LOTS 1 THRU 4, ROHAN SUBDIVISION GRADING AND DRAINAGE PLAN DRAWING: DRAWN BY: DATE: SHEET# SH-B 201605-GR.DWG 03-22-2016

Rohan Subdivision

Based upon the information provided in your resubmittal received 6/14/16, the above referenced Grading and Drainage Report and plan cannot be approved for Preliminary Plat, Grading Permit or Building Permit until the following comments are addressed:

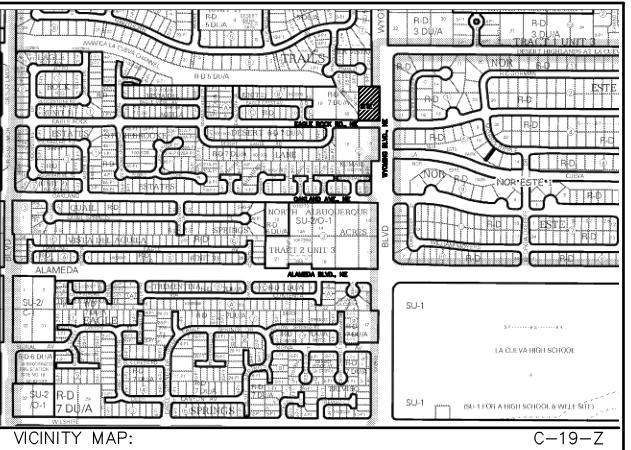
Provide a drainage easement through lot 3-PI for the acceptance of flows from Basin A, or make Basin A retain the flows with a sedimentation pond and then outfall into Wyoming Blvd. via a sidewalk culvert.
